REACTOR VESSEL OVERPRESSURIZATION  
DISTRIBUTION PER G. ZECH 10-21-76

Info concerning implementation option re installation of acceptable long-term improvements to mitigate overpressurization transients.....

Donald C. Cook Nuclear Plant Unit No. 1  
Docket No. 50-315  
DPR No. 58

This letter is in response to Mr. Dennis L. Ziemann's letter dated January 10, 1977 which requested that we identify the implementation option we have selected for the installation of acceptable long-term improvements to mitigate overpressurization transients. There were also staff positions and requests for additional information listed in enclosure 1 to Mr. Ziemann's letter. Our responses to the staff positions and requests for information are provided in Attachment 1.

RCS OVERPRESSURE PROTECTION  
 BLOCKED CIRCUIT (OPERATOR WARNING)

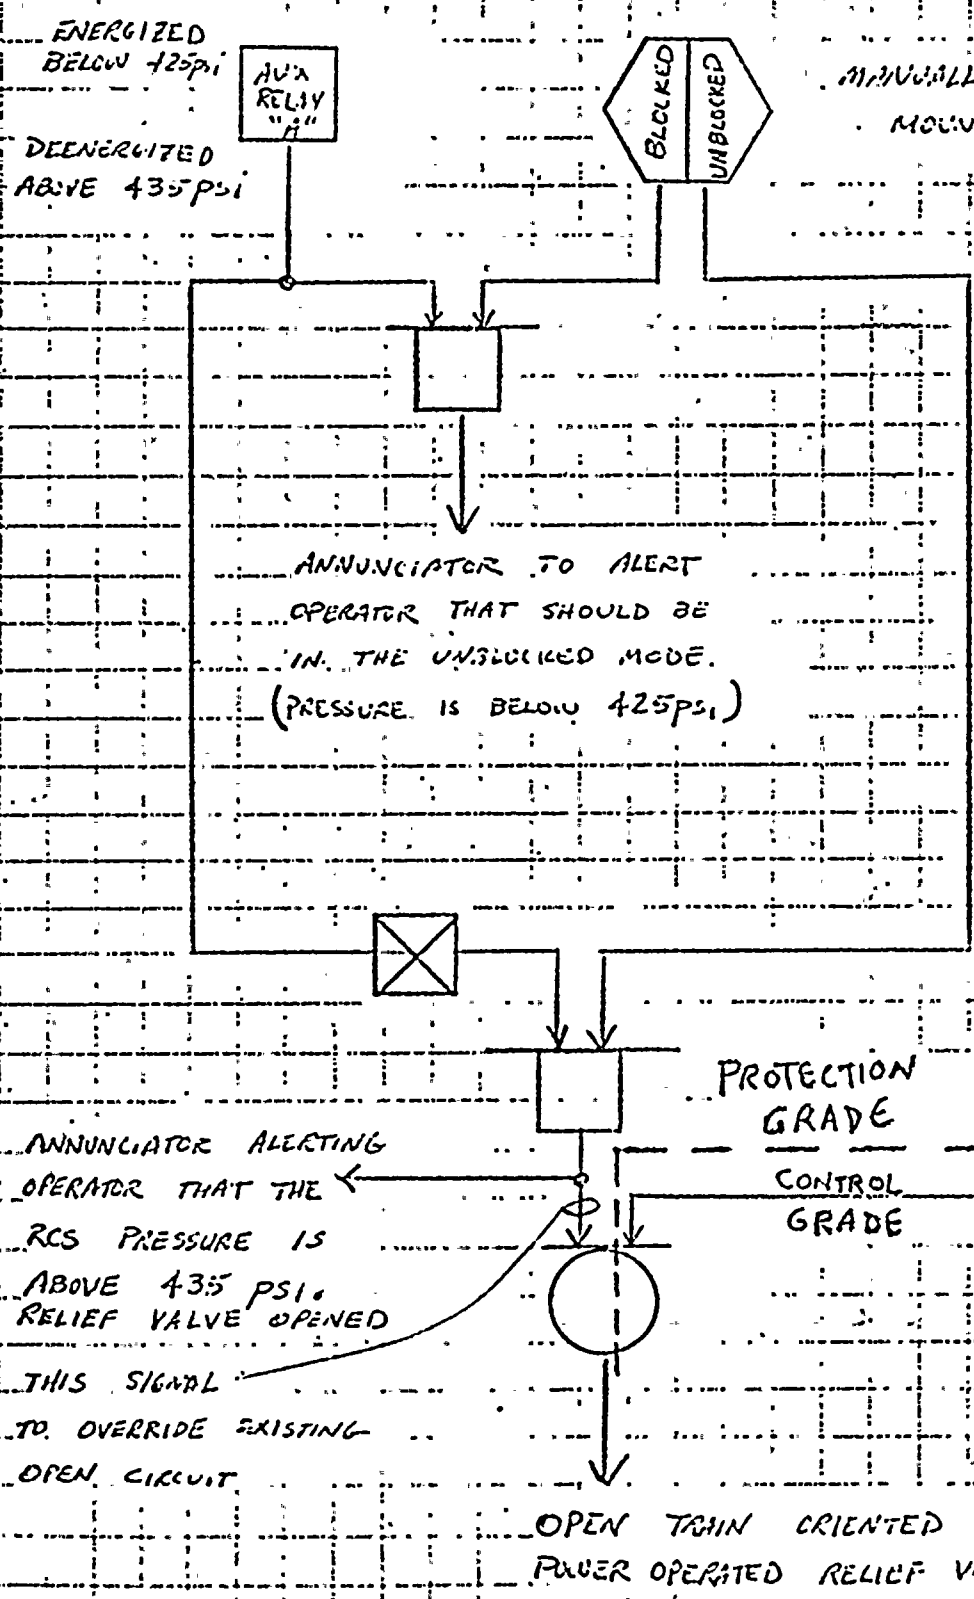
Attachment 2 presents two sketches which represent the control function - logic diagram for the circuits to be installed at the Cook Nuclear Plant to mitigate the effects of an overpressurization transient. This control scheme will be duplicated on both existing RCS wide range pressure transmitters with each train actuating one Pressurizer Power Operated Relief Valve.

This control scheme will be the long-term solution for RCS overpressure protection. The selection and ordering of hardware (e.g. - Block-Unblock switch) is currently underway. The estimated delivery for the hardware is late September 1977. The remaining equipment that is needed is already available or can be fabricated on site.

The mitigating system we have designed incorporates controls for two (2) of our existing Pressurizer Power Operated Relief Valves and the control scheme of Attachment 2. The mitigating system will represent good engineering practice and will not adversely affect plant safety or introduce potential common mode failures that could both cause a pressure transient and disable the protection system.
